Service Bulletin	Issue by After Sales
	Matching new LCAC range 2017 versus old LCAC range 2014/2016	20/11/2017
		Rev : 3 SB10ARS
		Page 1 to 4

Object :

For 2017, we are introducing a new LCAC range benefiting of new communication bus with **2 wires** only* not polarised S1/S2

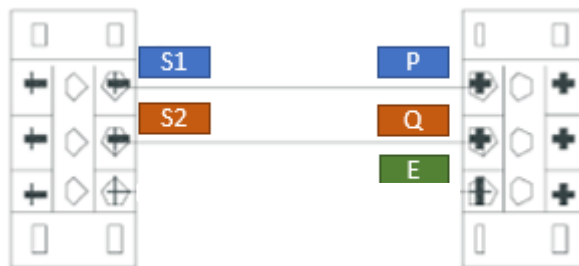
The question is the matching between **old** indoor units versus new outdoor units YMD **and** new indoor units versus **old** outdoor units YLD.

3 differents cases :

Case n°1 : Matching with old outdoor units YLD012 and new indoor unit size 12 **or** new outdoor units YMD012 versus old indoor units size 12 → does not work due to different communication protocol
